FAIRFAX COUNTY, VIRGINIA

MEMORANDUM

SUBJECT: Staff Analysis of the "Master Conceptual Plan for the Reston Town Center" and the "Conceptual Plan for Oak Park"

FILE NO: CC:68

**MASTER CONCEPTUAL PLAN - CIRCULATION**  
**TOWN CENTER DISTRICT PLAN**  
 RESTON LAND CORPORATION  
 SASAKI ASSOCIATES, INC.

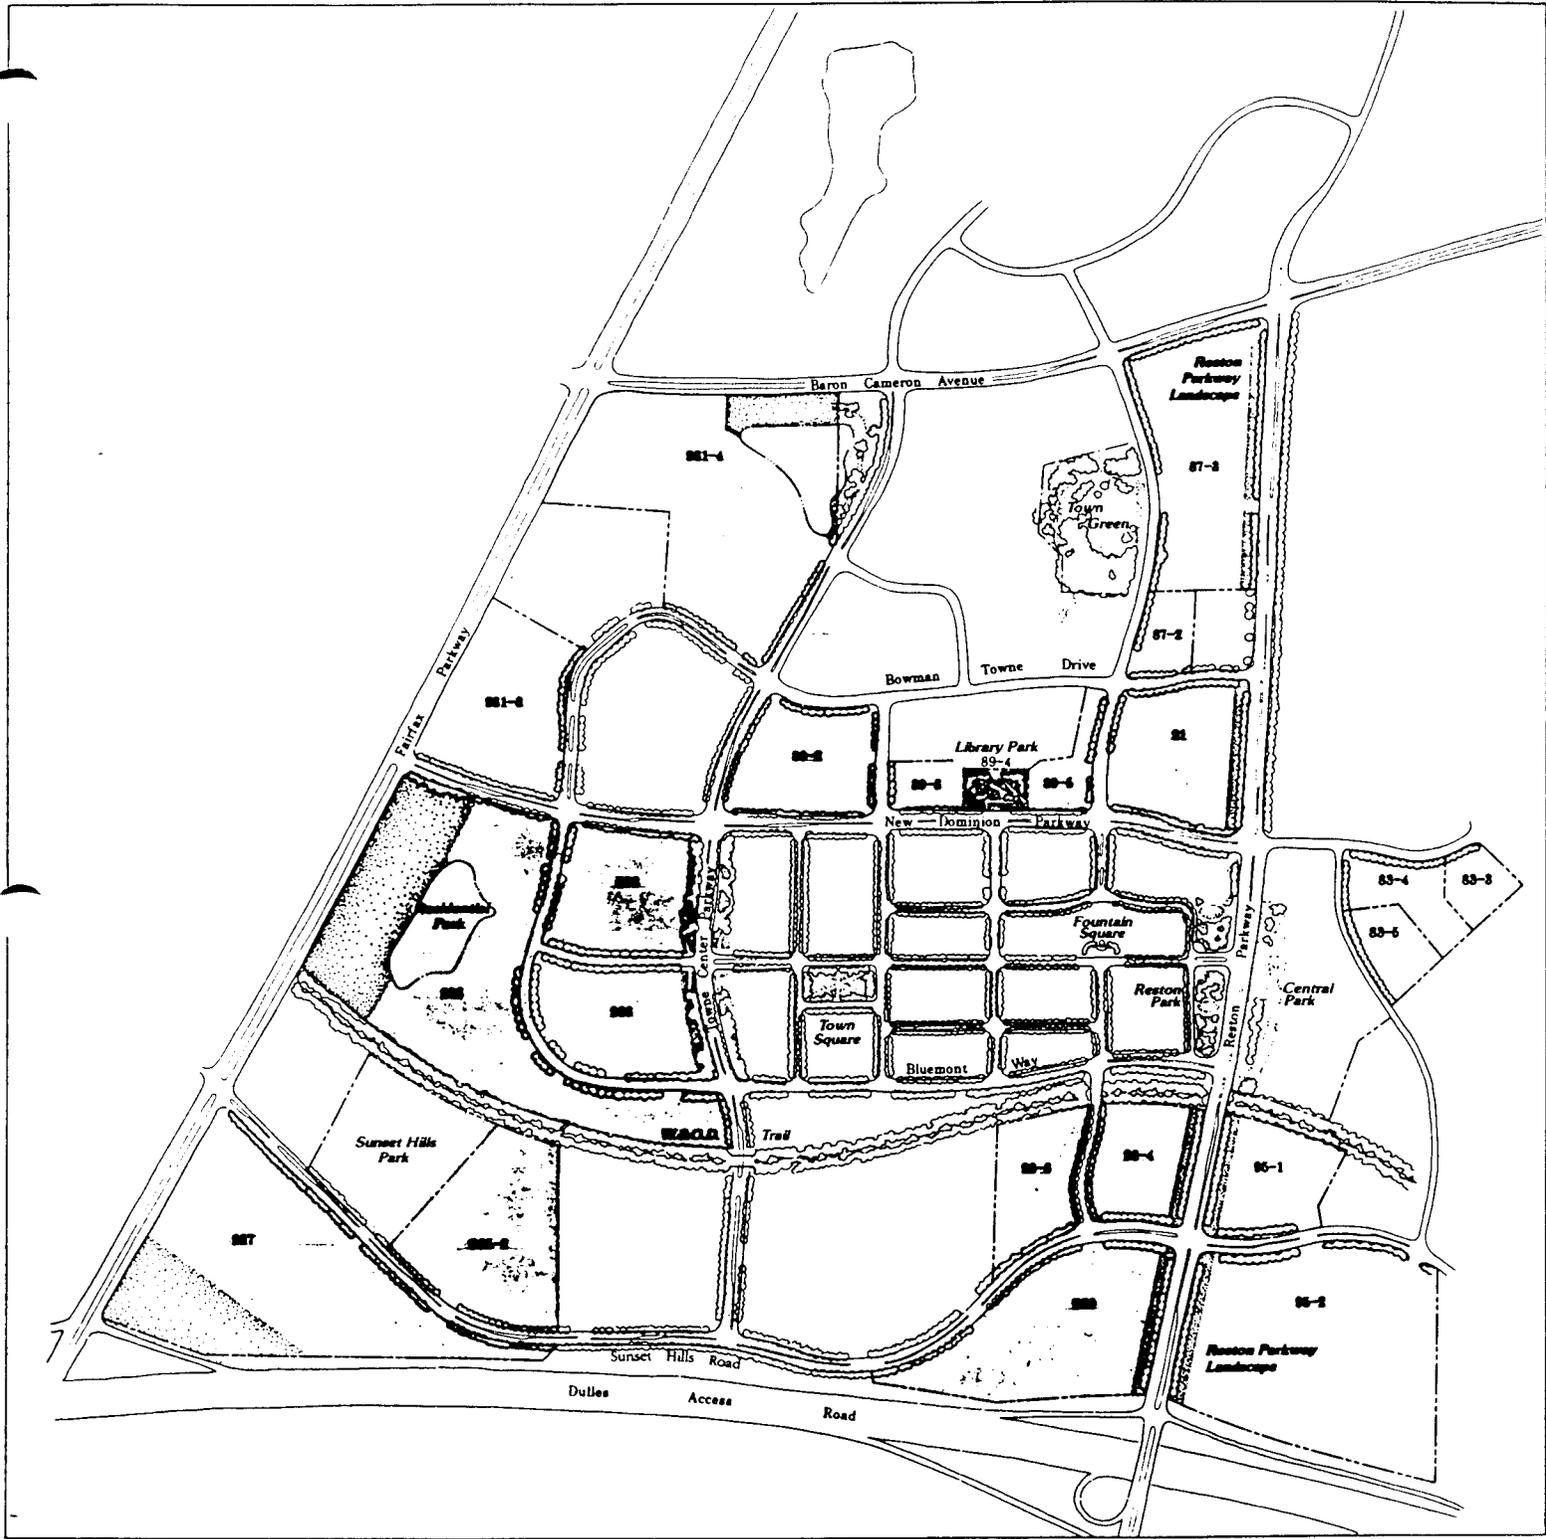
2. "Circulation Plan" - Sheet Number 2 depicts the approximate location of streets, sidewalks, pathways, regional trail system, bridges, underpasses, intersections, general entrance locations, and potential/alternative locations for transit facilities.

The comments from the Office of Transportation (Refer to Appendix 6) on the Master Conceptual Plan have been satisfactorily addressed as follows: no change is proposed to the Reston Town Center proffers and Note Number 1 states that "There shall be a transit facility within the Town Center to be located at one of the alternate locations shown or along the Dulles Access Road or at an alternate location within the Town Center Urban Core". Four (4) alternate locations for transit facilities, either for rail or bus, are shown on Sheet 2 of the plan, which are acceptable to staff. Note Number 1 also states that "Entrance locations, turn lanes, street widths and right-of-way are approximate and may be revised, moved, added or eliminated as part of the conceptual plan and/or site plan development process." Staff agrees that site specific transportation issues, as listed in Note 1, should be addressed at the conceptual plan or site plan stage of development in conformance with the Reston Town Center proffers.

**MASTER CONCEPTUAL PLAN - OPEN SPACE AND LANDSCAPE**  
**TOWN CENTER DISTRICT PLAN**  
 RESTON LAND CORPORATION  
 SASAKI ASSOCIATES, INC.

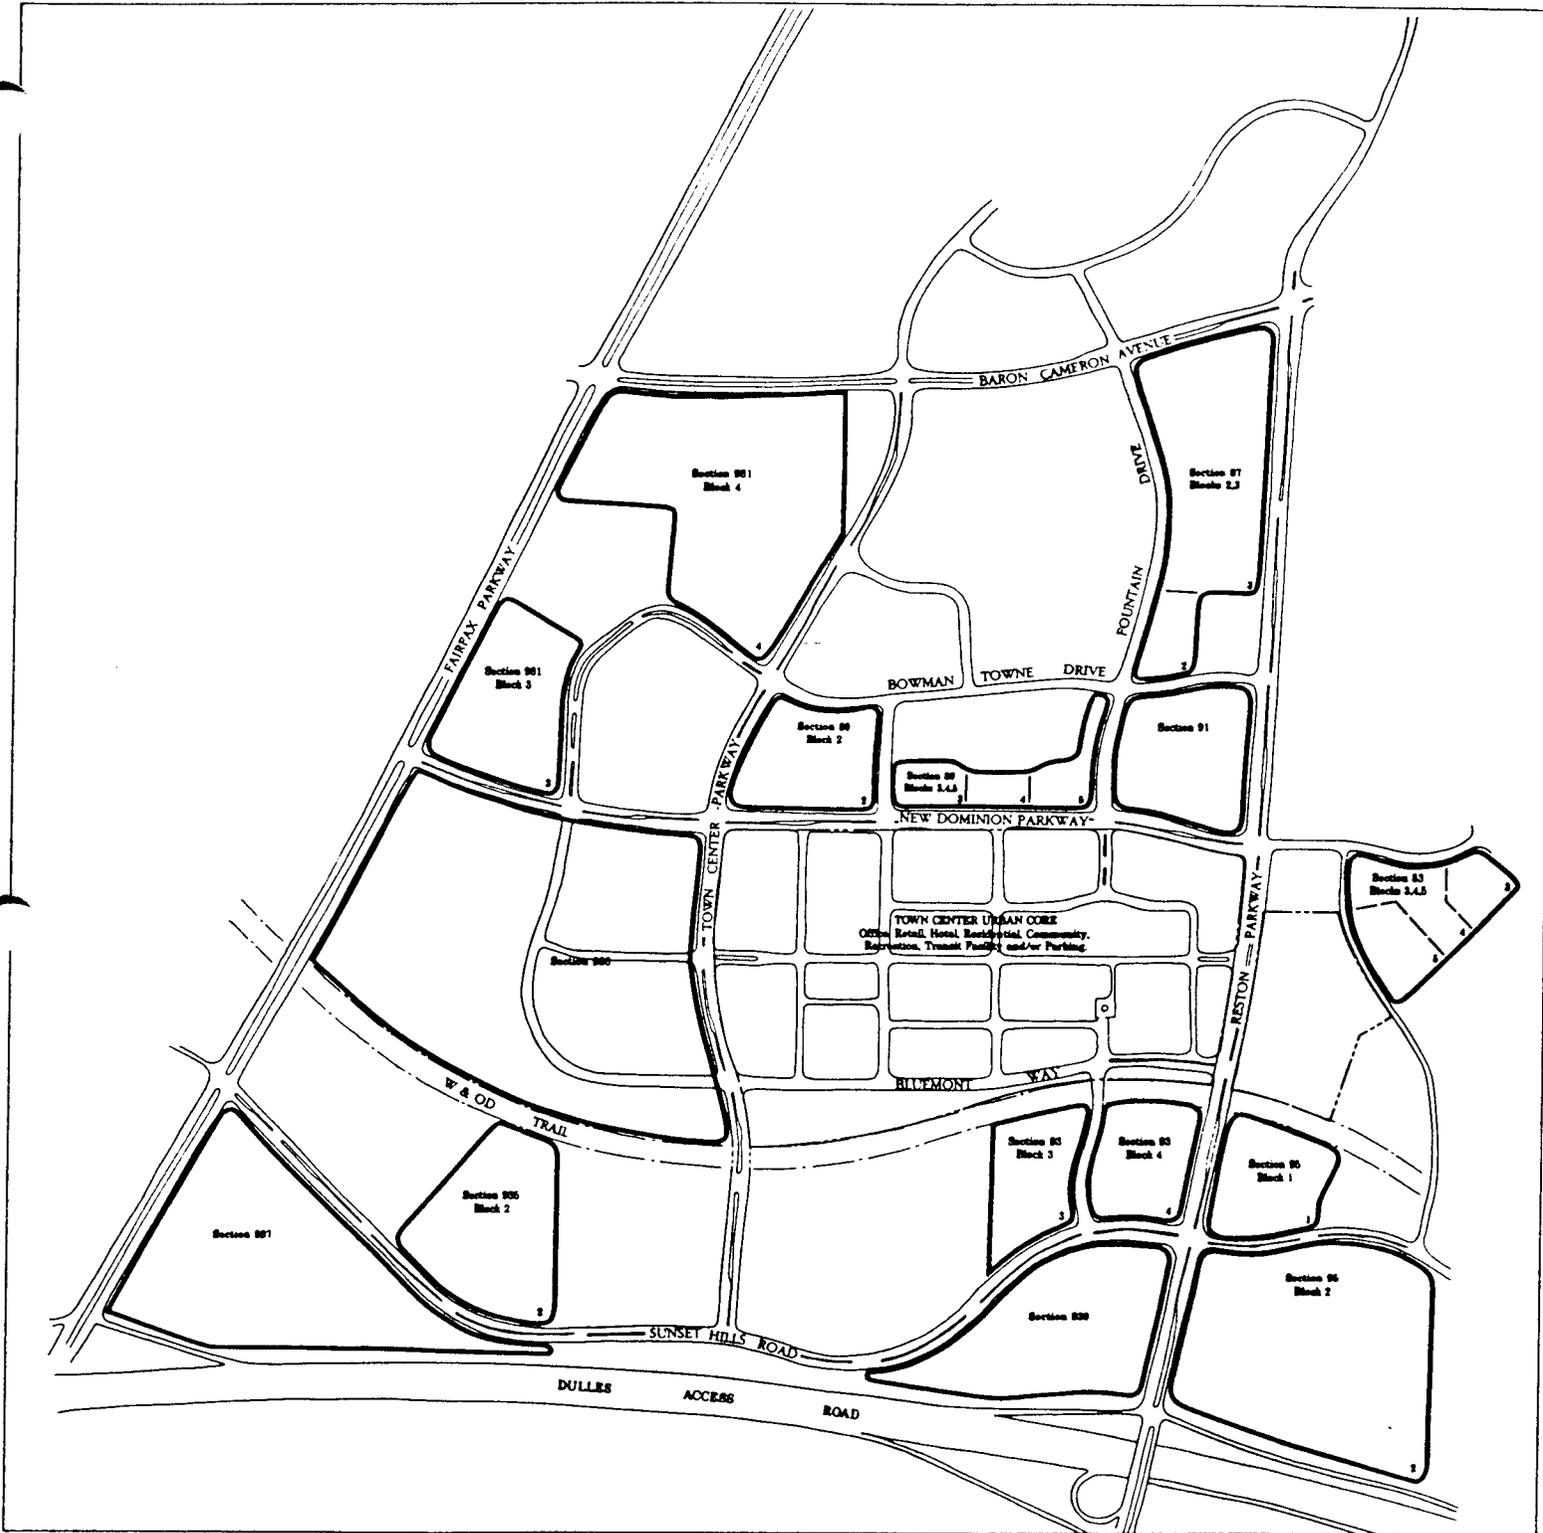
1. "Open Space and Landscape Plan" - Sheet Number 1 depicts the major open space areas proposed within the Reston Town Center and the conceptual landscaping, screening and existing natural buffer areas.
